Subject: Duke Energy Corporation
Catawba Nuclear Station, Units 1 and 2
Docket Numbers 50-413 and 50-414

Proposed Technical Specifications and Bases
Amendment
Technical Specification and Bases 3.6.10
Annulus Ventilation System (AVS)
Technical Specification and Bases 3.6.16
Reactor Building
Technical Specification Bases 3.7.10
Control Room Area Ventilation System (CRAVS)
Technical Specification Bases 3.7.12
Auxiliary Building Filtered Ventilation Exhaust
System (ABFVES)
Technical Specification Bases 3.7.13
Fuel Handling Ventilation Exhaust System (FHVES)
Technical Specification and Bases 3.9.3
Containment Penetrations
Technical Specification 5.5.11
Ventilation Filter Testing Program (VFTP)
TAC Numbers MB7014 and MB7015

RESPONSE TO NRC REQUEST FOR ADDITIONAL INFORMATION

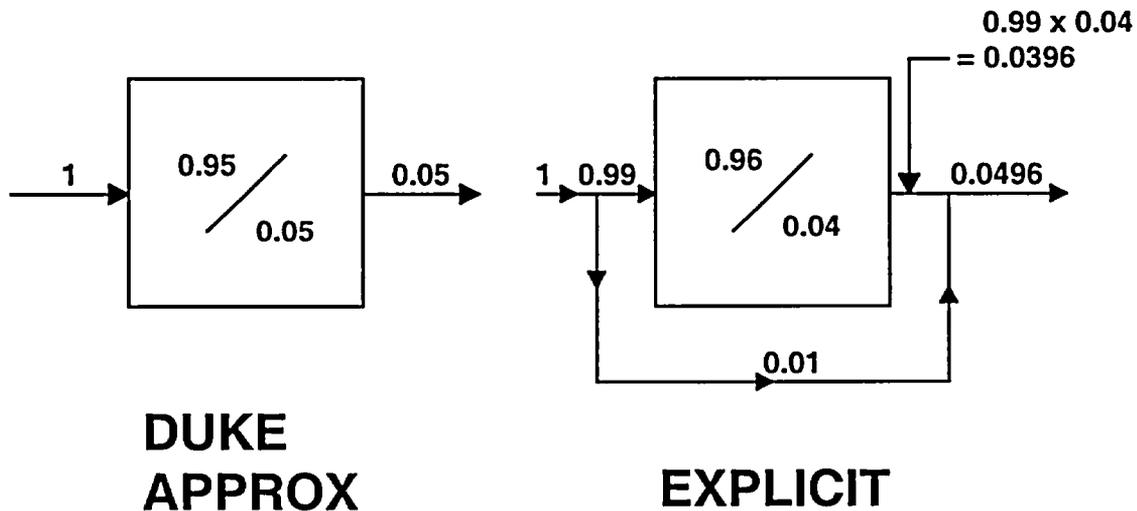
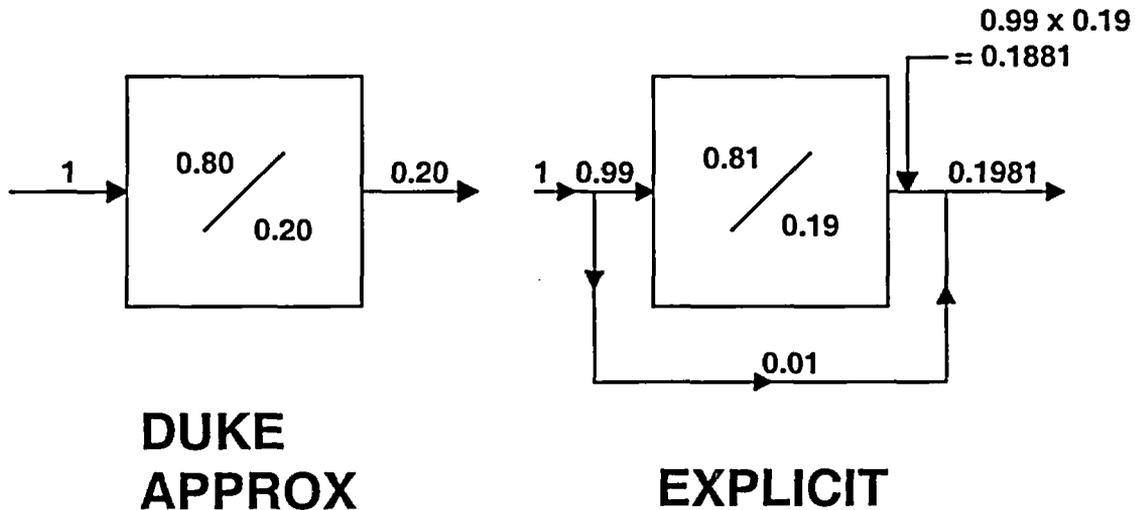
- 2) It is the staff position that charcoal filter testing should be done in accordance with the guidance of RG 1.52, Rev. 2, as has been committed to by the Catawba Plant. As such, a 2 inch charcoal filter should be tested to a laboratory efficiency of 97.5%, thereby permitting licensee to claim 95% efficiency for both organic and elemental iodine in the dose analysis while providing a safety factor of 2, as outlined in GL 99-02. See Regulatory Position 6.a in RG 1.52, Rev. 2, and GL 99-02 for further discussion of the staff's position. Considering this discussion on filter testing and assumed filter efficiency in dose analyses, the explanation of how Catawba has accounted for the 1% system bypass for the in-place testing by adjusting the filter efficiency is not clear to the staff. Provide a clear explanation of how the allowable bypass is accounted for in your dose analysis.

The degree of conservatism in the model employed within Duke may be calculated by taking $1 - \eta_p = 0.04$ for diatomic iodine and $f_f = 0.01$ for diatomic iodine bypass. Set f_f and f_b to 0.99 and 0.01. The resulting values for $1 - \eta_T$ and comparison to $1 - \eta_d$ are presented below:

For diatomic iodine, $1 - \eta_T = 0.0496$ vs. $1 - \eta_d = 0.05$.

The following is a pictorial demonstration of this comparison for diatomic iodine:

For organic iodine compounds, $1 - \eta_T = 0.1981$ vs. $1 - \eta_d = 0.2$. The pictorial demonstration of this comparison for organic iodine compounds follows as:
